Joint Public Notice

Application for a Department of the Army Permit and a Washington Department of Ecology Water Quality Certification and/or Coastal Zone Management Consistency Concurrence – ERRATUM/REVISION

Reference No.: NWS-2019-162
Name: Lakeport Reach LLC

ERRATUM/REVISION: This revises the information on wetland impacts and mitigation as described in a Corps/Ecology Joint Public Notice dated March 28, 2019.

FIGURE 2 of 15

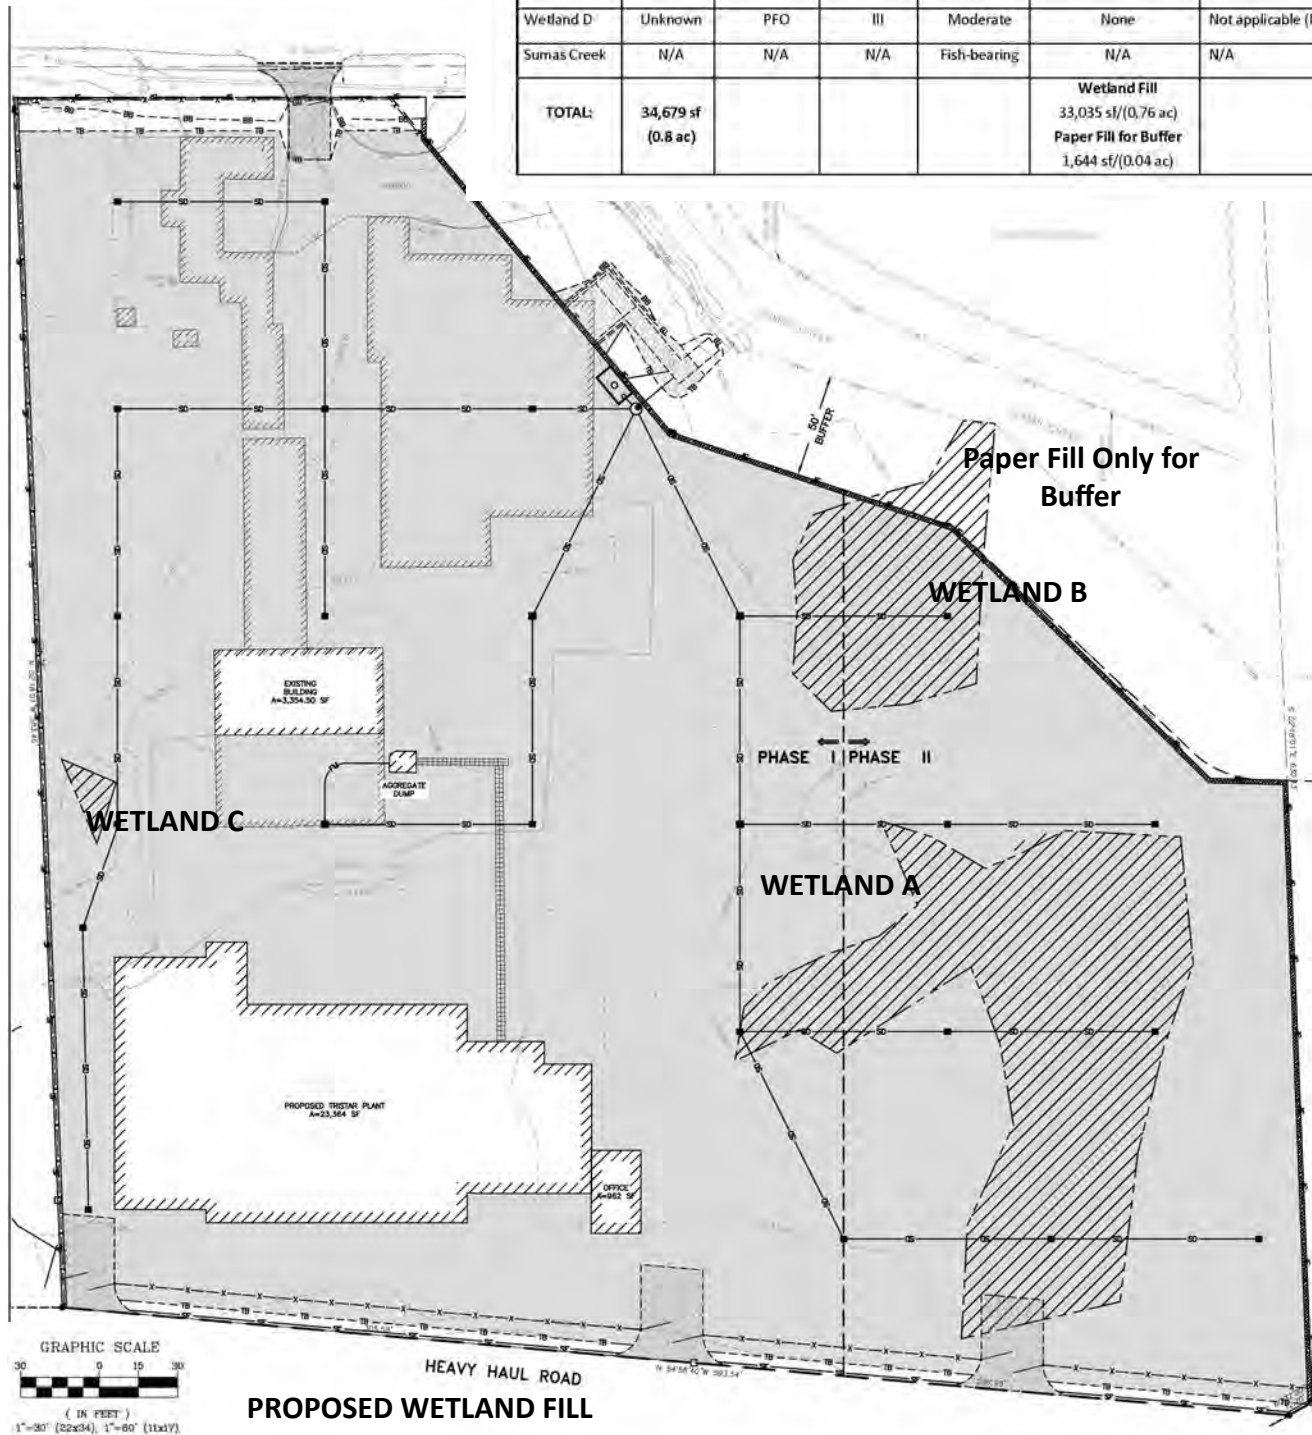
The corrected information is as follows: Based on additional sampling at the site, the area of existing wetlands was increased by 0.17 of an acre to a total of 0.80 of an acre. The applicant now proposes to fill 0.76 of an acre of wetlands to construct the project as described in the original public notice (no project revisions). In addition to direct impacts, 0.04 of an acre of indirect impacts would occur to Wetland B from inadequate buffers (wetland area used as “paper buffer”). The applicant would increase the proposed mitigation to 5.60 acres of wetland enhancement at the adjacent SDL mitigation site. Revised colored and non-colored project figures are provided.

PROPOSED WETLAND IMPACTS						
Wetland	Size	Cowardin Class	WDOE Category	Habitat Function	Proposed Wetland Fill	Fill Purpose & Phasing
Wetland A	24,752 sf	PEM/PFO	III	Moderate	24,752 sf	Phases 1 & 2 – Product storage & internal roads
Wetland B	9,486 sf	PEM	III	Moderate	Wetland Fill 7,842 sf Paper Fill for Buffer 1,644 sf	Phase 1 – Product storage, internal roads & retaining walls
Wetland C	441 sf	PEM	III	Moderate	441 sf	Phase 1 – Product storage & internal roads
Wetland D	Unknown	PFO	III	Moderate	None	Not applicable (N/A)
Sumas Creek	N/A	N/A	N/A	Fish-bearing	N/A	N/A
TOTAL:	34,679 sf (0.8 ac)				Wetland Fill 33,035 sf/(0.76 ac) Paper Fill for Buffer 1,644 sf/(0.04 ac)
